**STATE OF CONNECTICUT
CONNECTICUT SITING COUNCIL**

IN RE: :
 :
 : DOCKET NO. 510
 :
 NEW CINGULAR WIRELESS PCS, LLC :
 D/B/A AT&T AND TARPON TOWERS II, :
 LLC APPLICATION FOR A CERTIFICATE :
 OF ENVIRONMENTAL COMPATIBILITY :
 AND PUBLIC NEED FOR THE :
 CONSTRUCTION, MAINTENANCE AND :
 OPERATION OF A :
 TELECOMMUNICATIONS FACILITY : August 1, 2022
 LOCATED AT 92 GREENS FARMS ROAD,
 WESTPORT, CONNECTICUT

**NEW CINGULAR WIRELESS PCS, LLC D/B/A AT&T AND TARPON
TOWERS II, LLC RESPONSES TO CONNECTICUT SITING COUNCIL
PRE-HEARING INTERROGATORIES DATED JULY 8, 2022**

Existing Coverage
3700 MHz LTE

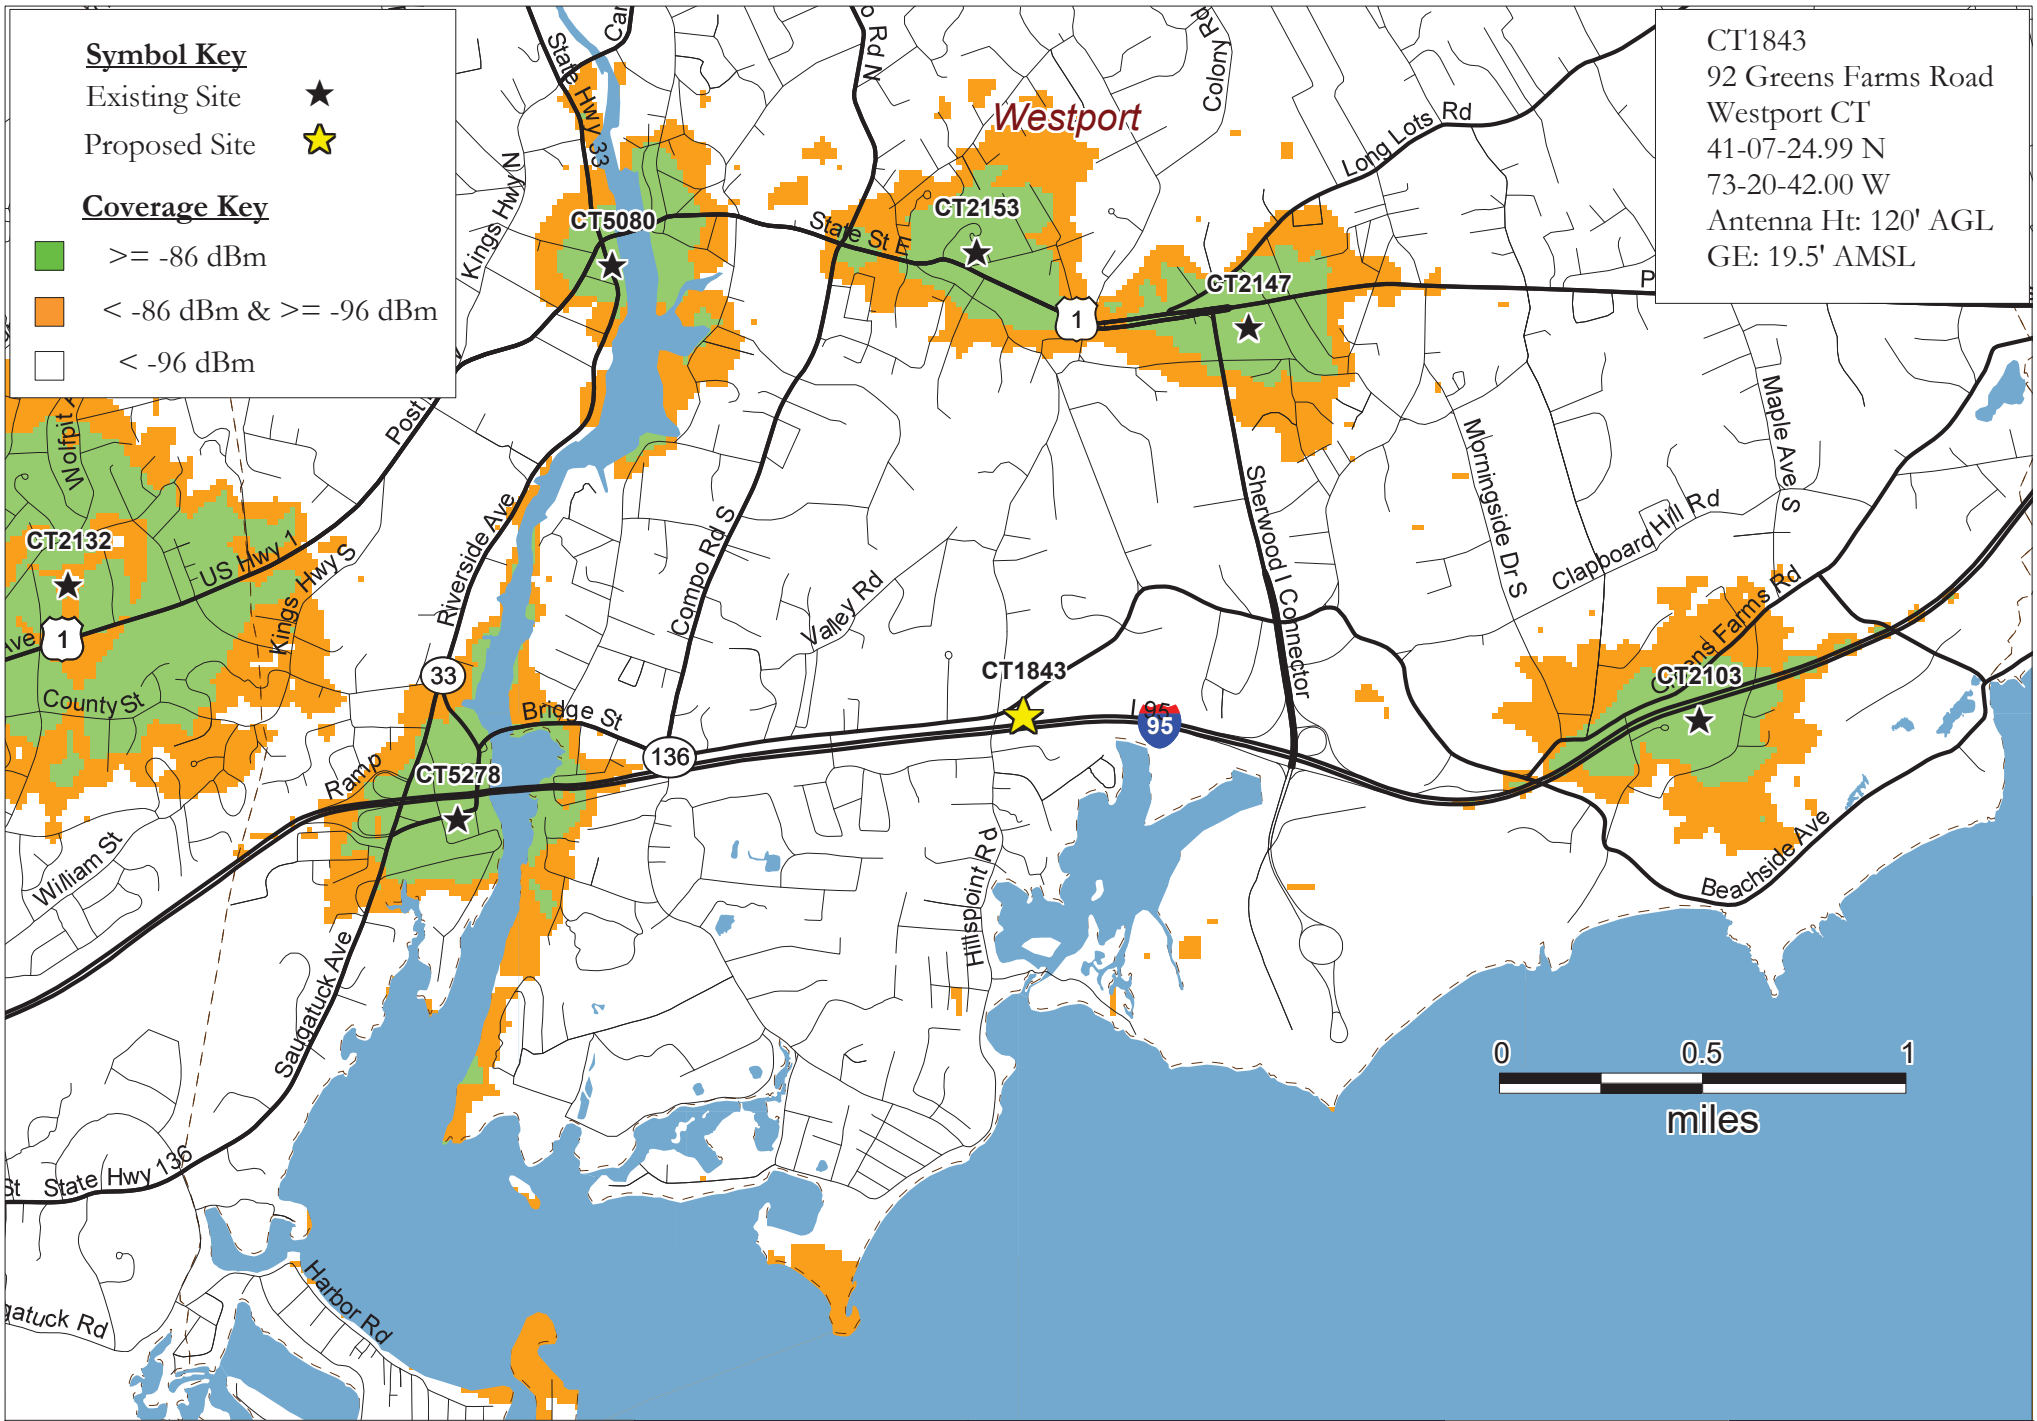
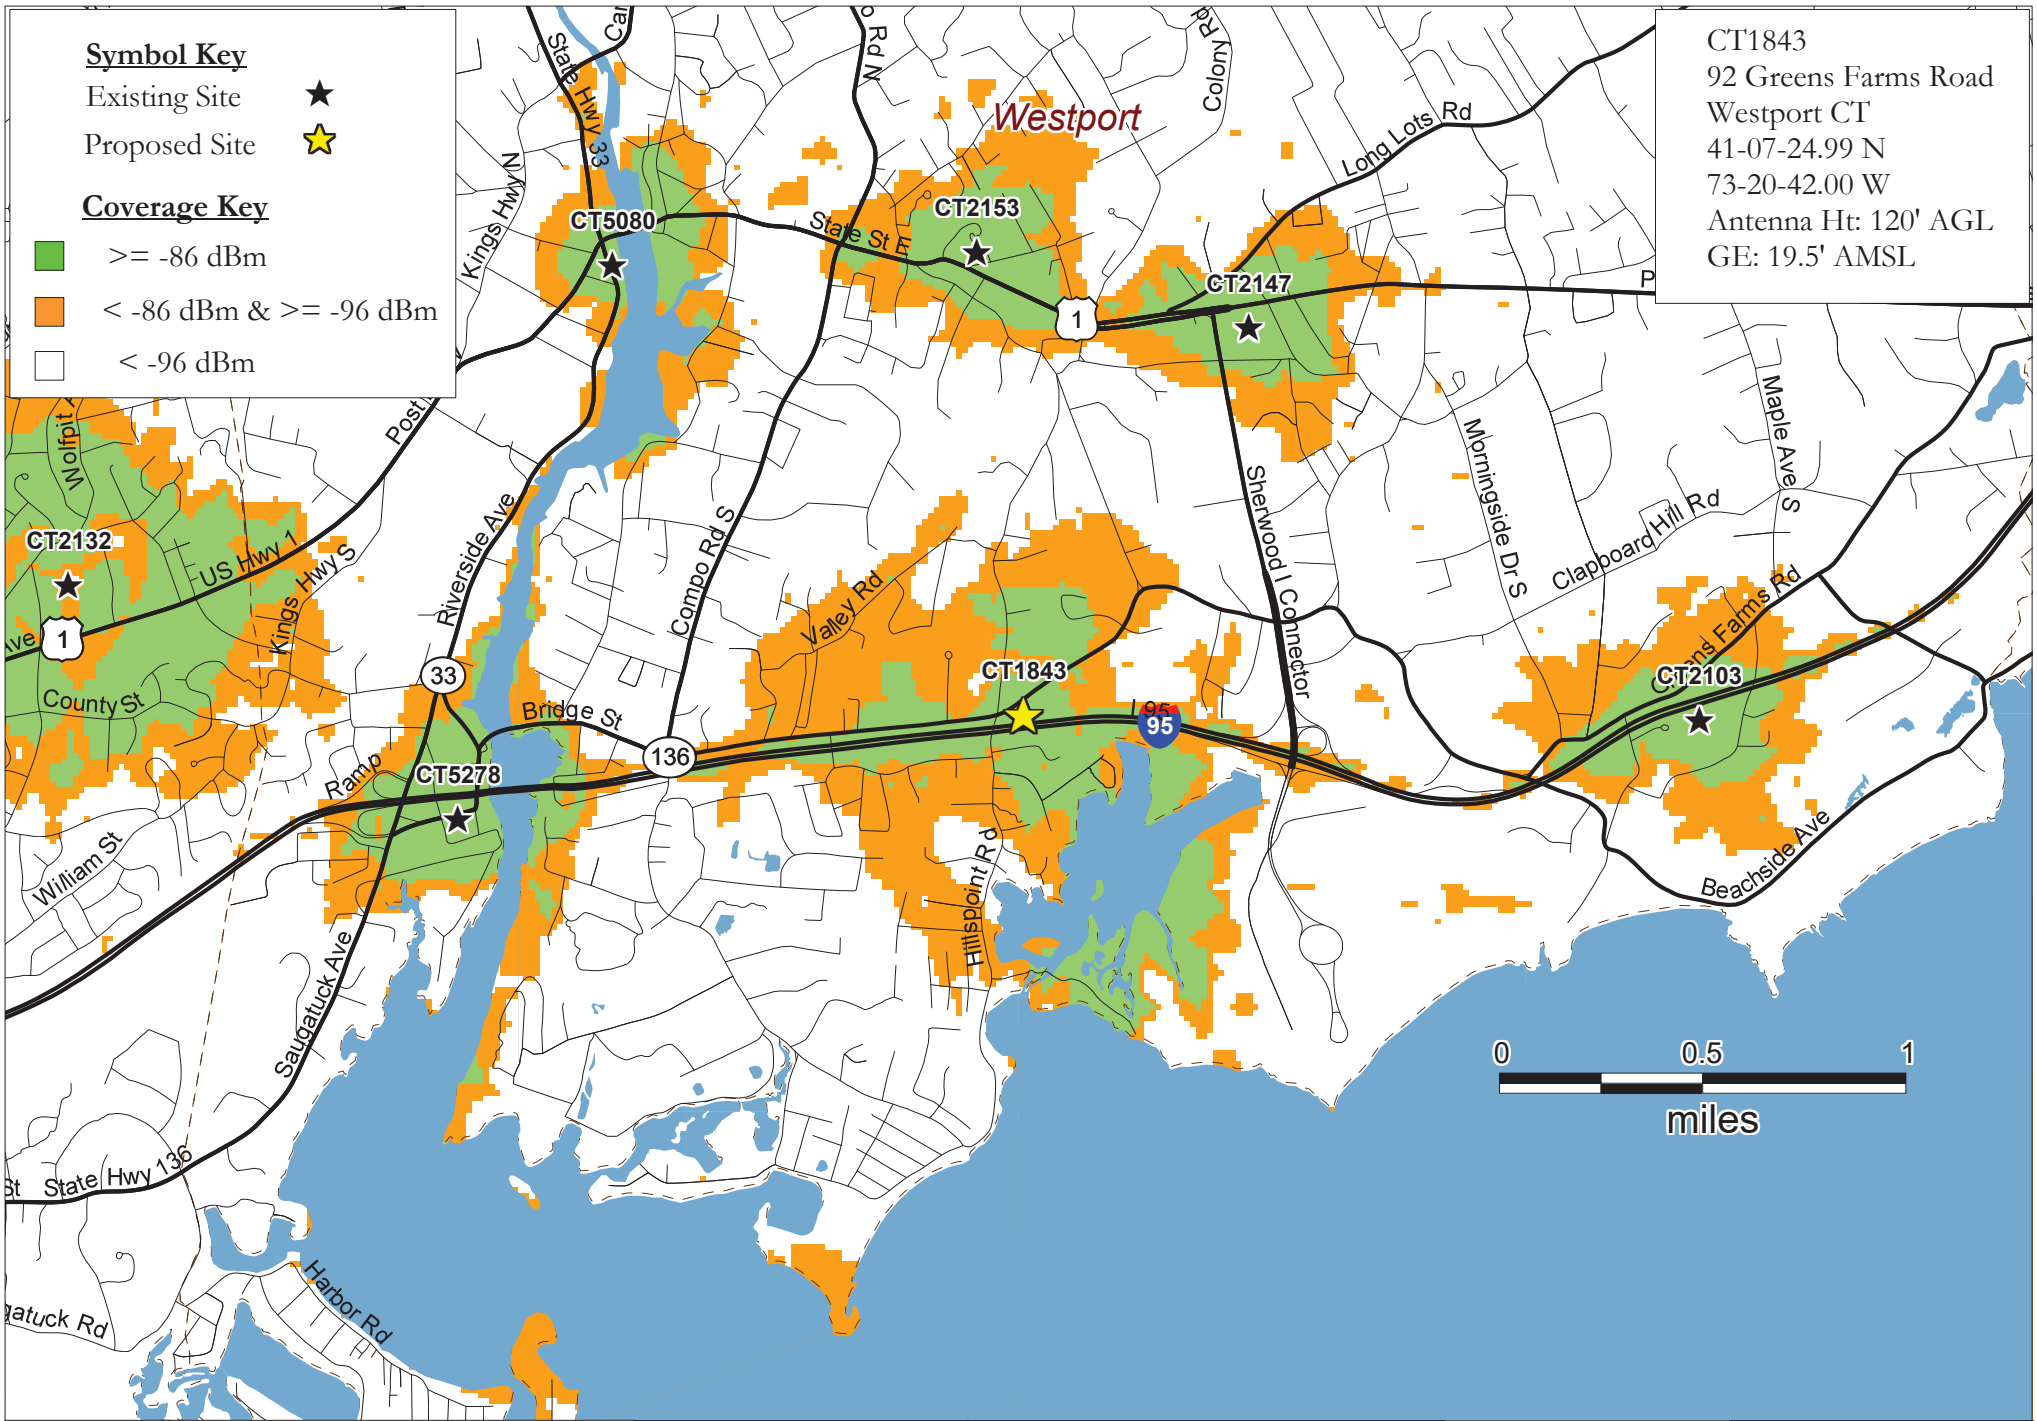
28. Provide coverage models for existing and proposed 1900 MHz, 2100 MHz and 3500 MHz services.

Please see plots included in Exhibit 28 attached hereto.

Please see the coverage plots included in Exhibit 28. The predicted coverage footprints are as follows:
